# Independent Peer Review Panel

## IPRP Report No. 7, November 21, 2014

### **Comments on PG&E's Central Coastal California Seismic Imaging Project Report part 1: offshore seismic studies intended to reduce the uncertainty in seismic hazard at Diablo Canyon Power Plant**

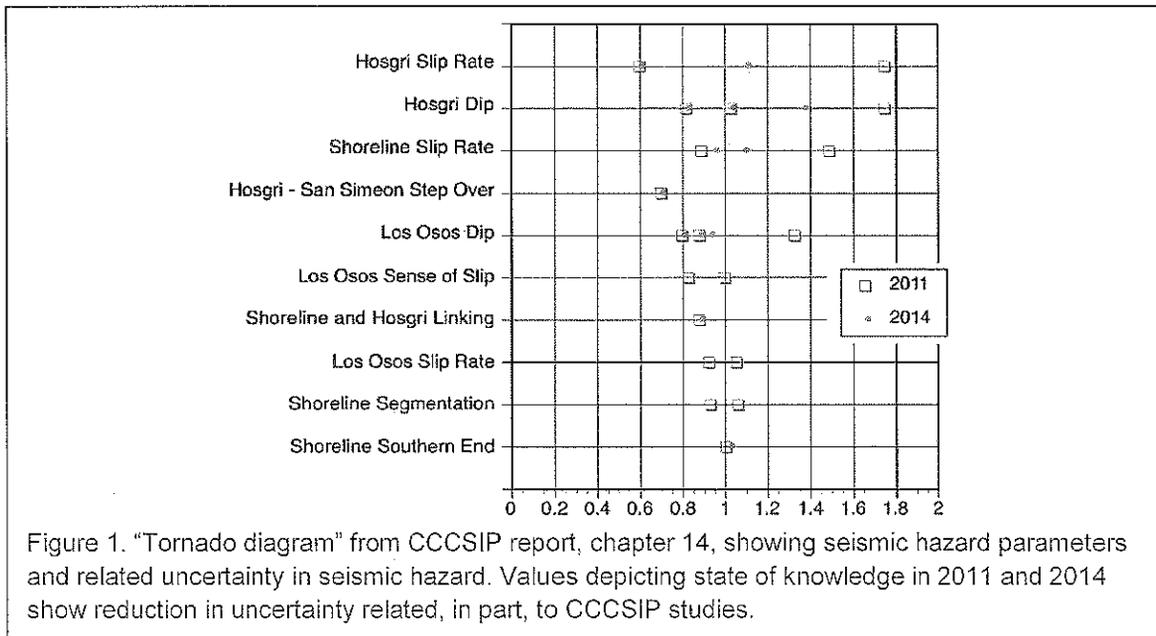
At the IPRP meeting on October 23, 2014, PG&E project manager Stuart Nishenko presented an update of the “tornado diagram” from the 8/11/2011 memo report. In the updated “tornado diagram” (Figure 1), the distance between points related to a hazard parameter is based on uncertainty in seismic hazard resulting from that parameter. In this type of diagram, parameters that are poorly constrained and have a large effect on hazard

are shown as widely separated points at the top of the diagram. Closely spaced points shown near the base of the diagram can be either parameters that are well-constrained or parameters that are poorly-constrained but have slight effect on hazard. As stated by Dr. Nishenko, reducing the uncertainty in the parameters near the top of the “tornado” will have the greatest effect in reducing the uncertainty in hazard. The depiction of uncertainty in 2011 and 2014, particularly the lower uncertainty for the parameters at the top of the “tornado” show how much studies described in the CCCSIP report have decreased the uncertainty in seismic hazard. Due to the limited time between the issuing of the CCCSIP report and this review, the IPRP has not independently calculated the uncertainty in hazard related to these parameters, but finds that the pattern of reduction in uncertainty is consistent with the updated data and its expected impact on seismic hazard calculations. The IPRP notes that the parameters shown on the “tornado diagram” are all “seismic source characterization” parameters, other parameters, especially “site conditions” or “site amplification” parameters can have equal or greater impact on seismic hazard calculations as any shown on Figure 1. Site conditions and seismic amplification factors were the subject of IPRP Report #6 and sections of the CCCSIP report. Those factors will be addressed in a subsequent IPRP report.

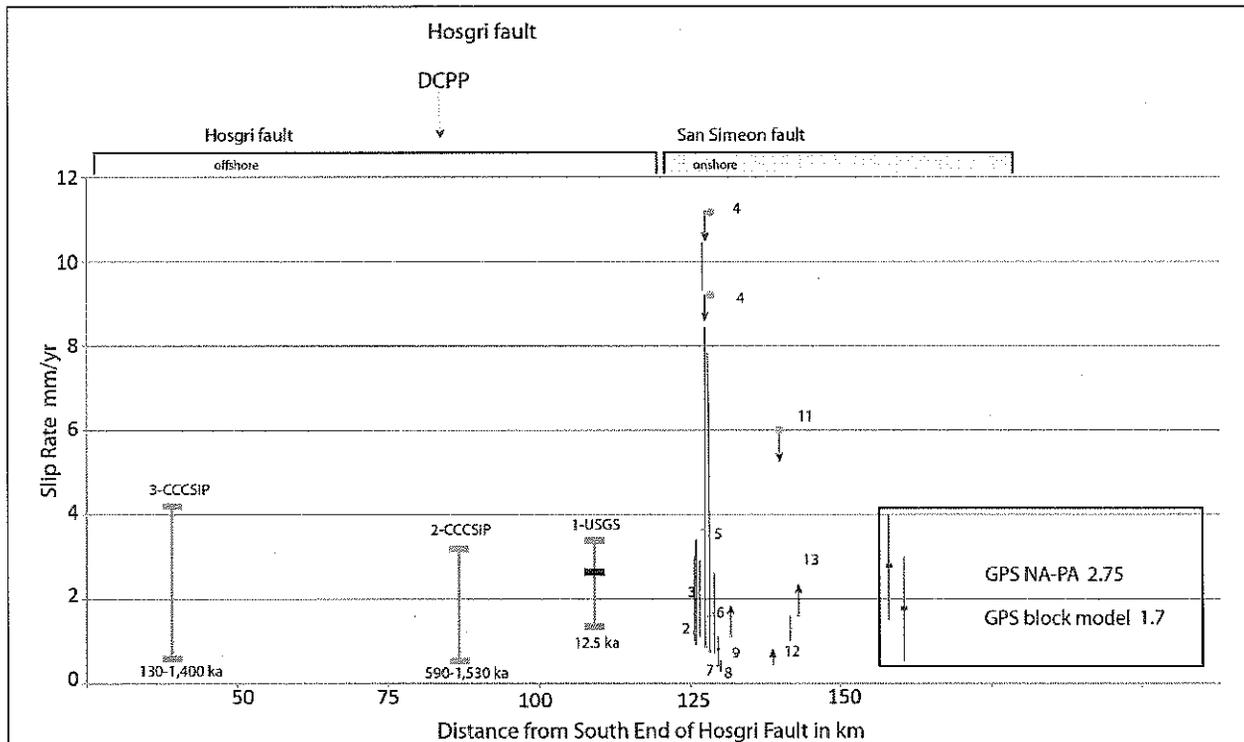
Two studies described in the CCCSIP report and one by USGS add to our knowledge of the Hosgri fault slip rate. Each of these studies includes estimates of the age and amount of offset of a feature that crosses the fault. The offset of the cross-Hosgri slope reported by Johnson et al. (2014) has significant uncertainties, as does the age estimate, which are considered in the estimate of slip rate. The resulting slip rate is an average over the past 12 ka, a period that is considered clearly applicable to current seismic hazard estimates. The studies for the CCCSIP rely on correlations of submarine channels across the fault. This correlation is relatively convincing at Pt Sal, but less so in Estero Bay. Age estimates of the channels depend on regional correlations of unconformities and age estimates based on correlation of the unconformities with global sea-level curves. The CCCSIP reports slip rates from Estero Bay and Point Sal based on interpreted channel offsets and preferred age estimates based on correlations with dates of global sea-level low stands. Uncertainties in these values and alternative models for correlation with sea-level curves are described in the text, but are not reflected in a final "preferred" slip rate value. We do not see a strong reason to prefer correlation of the channels with the age of one sea level low stand over the others, or even a strong reason for correlation with any sea level low stand, so would summarize

the slip rate determined from the Point Sal study as  $2.2 \pm 1.8$  mm/yr, rather than the reported  $1.8 \pm 0.4$  mm/yr. The large uncertainty in the slip rate is a consequence of large uncertainties in age estimates. In addition, estimated ages of the offset channels at both sites are in the range of about a half million years. Because slip rates may change over time, slip rates averaged over long times may not be as applicable to seismic hazard estimates. A summary of slip rate studies on the Hosgri fault, updated from the figure in IPRP report #5, is shown as Figure 2. The net result of studies reported in the CCCSIP report and by Johnson et al. (2014) is that uncertainty in the slip-rate on the Hosgri fault has been decreased and uncertainty in seismic hazard has decreased. This decrease is largely the result of the previous upper-bound slip rate being incompatible with newer geodetic and geologic data, including the results of the CCCSIP studies.
